**Re: Buddhist Housing, 308 Wisconsin St NE, Traffic Circulation Layout**  
**Architect's Stamp dated 3-21-14 (K19D147)**

# TRAFFIC CIRCULATION LAYOUT

**Re: Buddhist Housing, 308 Wisconsin St NE, Traffic Circulation Layout  
Architect's Stamp dated 3-5-14 (K19D147)**

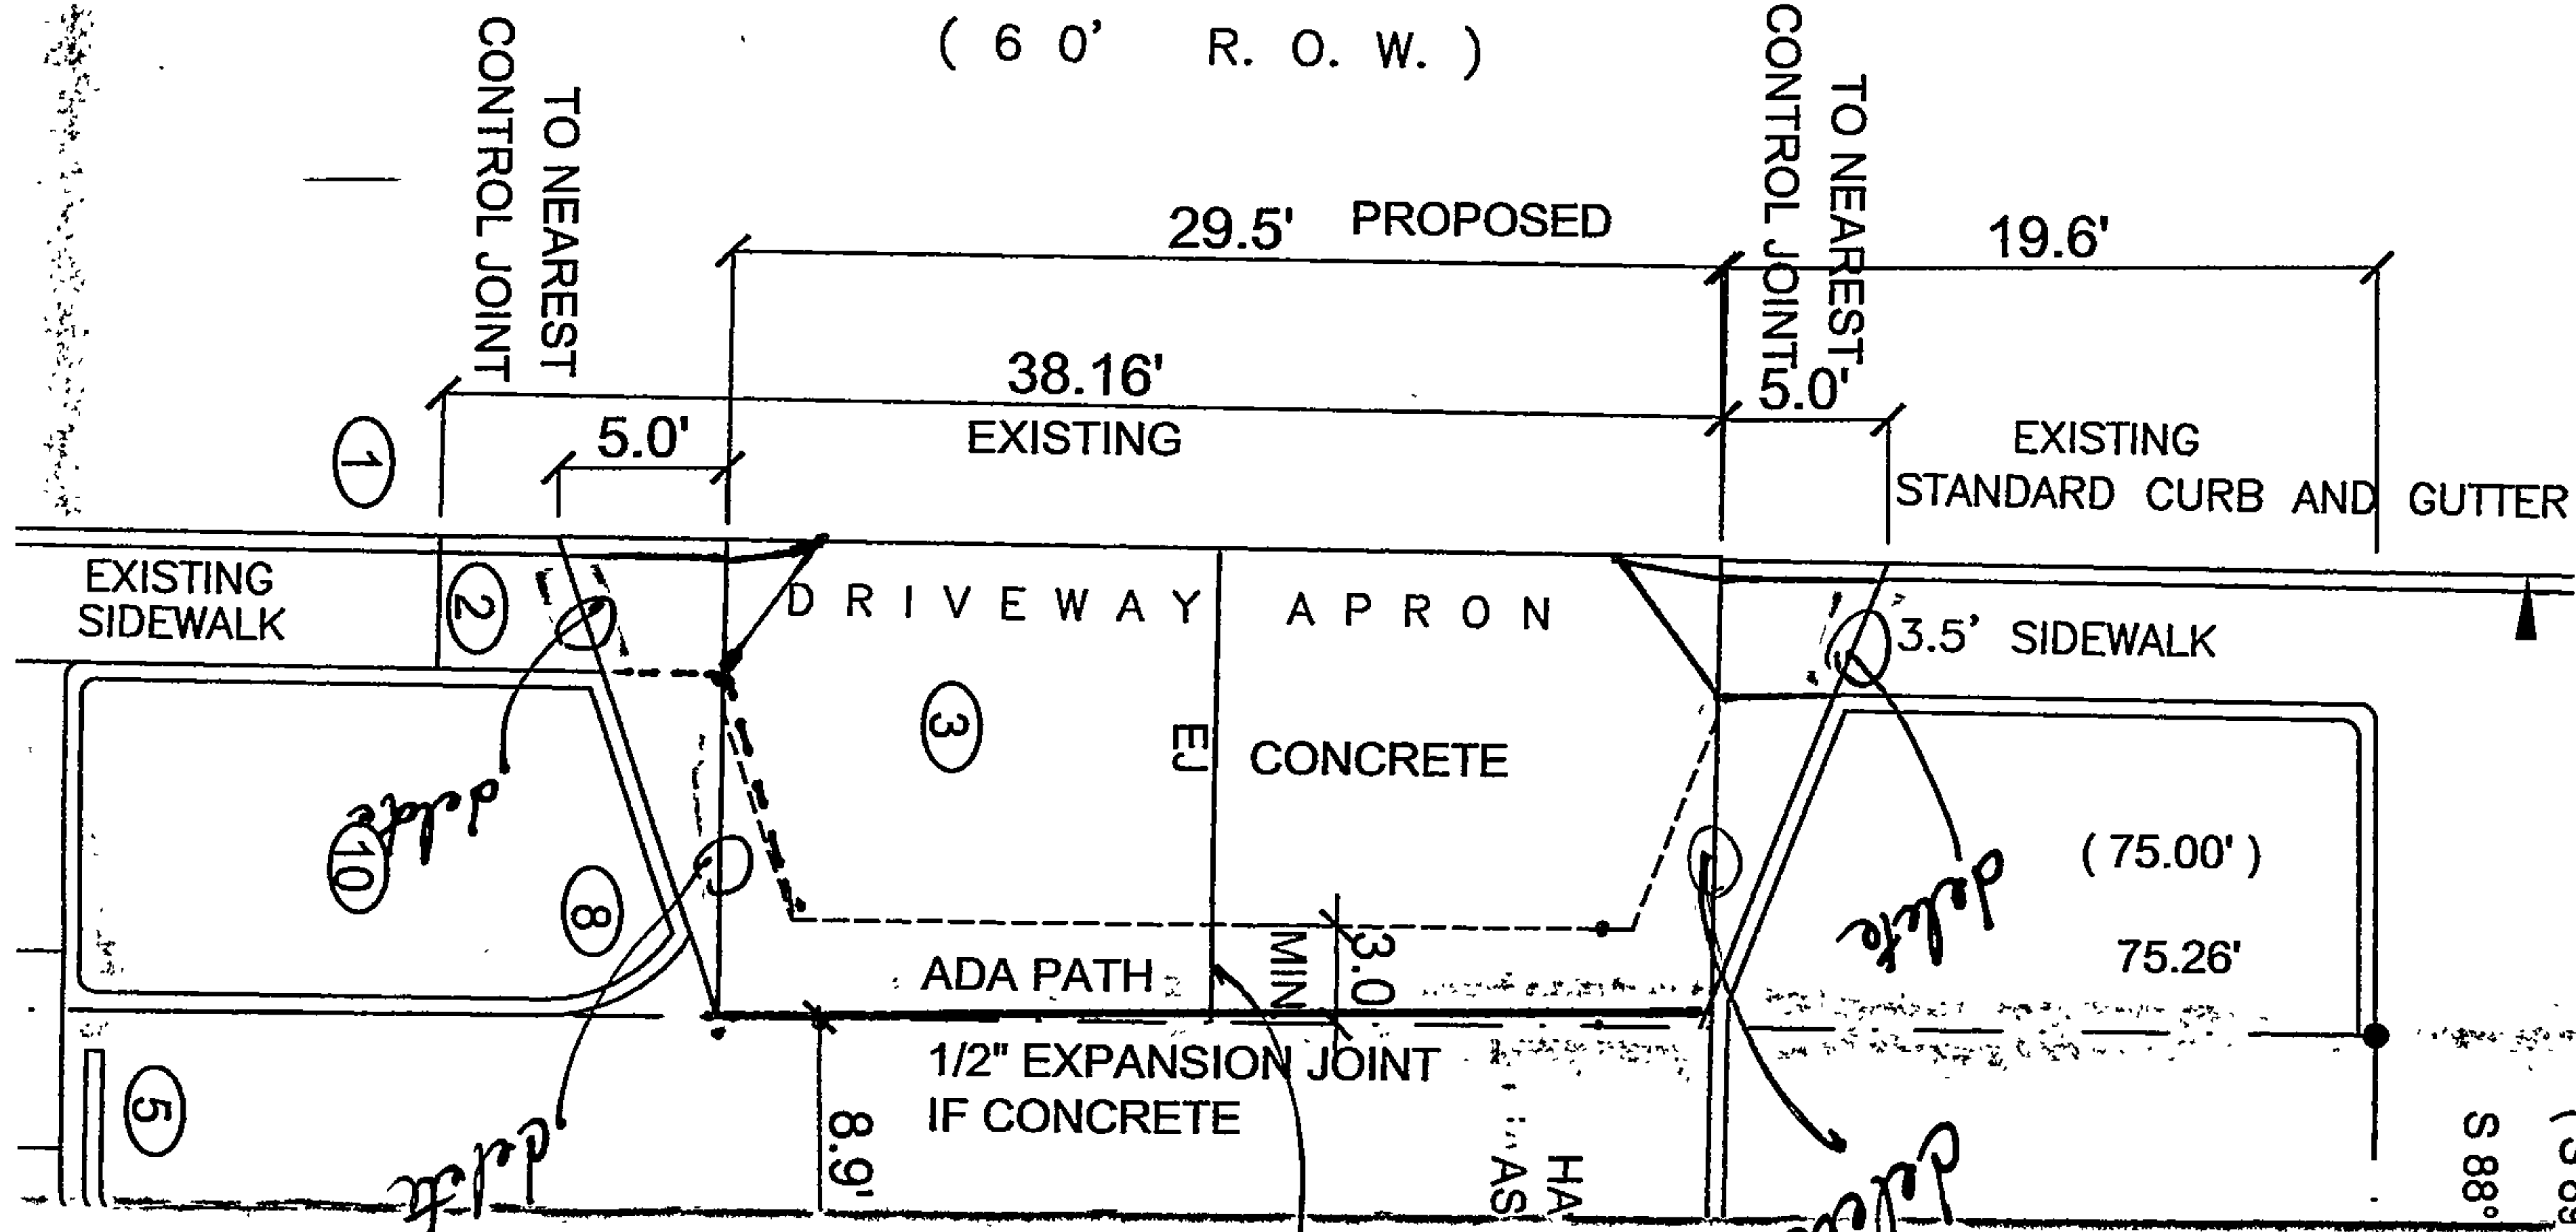
- Recheck the Legal description, what you provided does not match City's GIS.
- Remove text in TCL Legend that implies sidewalks intercept landscaping, notes 9 & 10.
- Remove note 2 and replace with different language to imply the existing drive pad is to be removed and replaced with COA standards for sidewalk, curb and gutter, COA STD DWG #2430 & #2415.
- The location of the new #2425 drive pad is provided w/ note 3.
- Add a note to clarify ADA sidewalk diverted to back of drive pad, minimum 3 ft, no greater than 2% cross-slopes.
- Clarify with line type what is to be built and remove lines that creates confusion, see attachment.

*Check Accuracy:*

*Block: 24*

*Lot: 8A*

*Address: 308 306 314 312  
310*

*Remove Existing Curb Cut  
Replace w/ COA STD DWG #2430 Sidewalk  
and #2415 Stno. Curb & Gutter.*

*12. 3' min ADA sidewalk ( $\geq 2\%$  Cross-Slope)  
located back of new drivepad.*

- Linetype is confusing - delete lines
- Appear to Propose large 5 ft transition wings.
- must show clearly 3' min ADA sidewalk
- Proposed (No greater than 2% Cross-slope)

Add  
Key Note
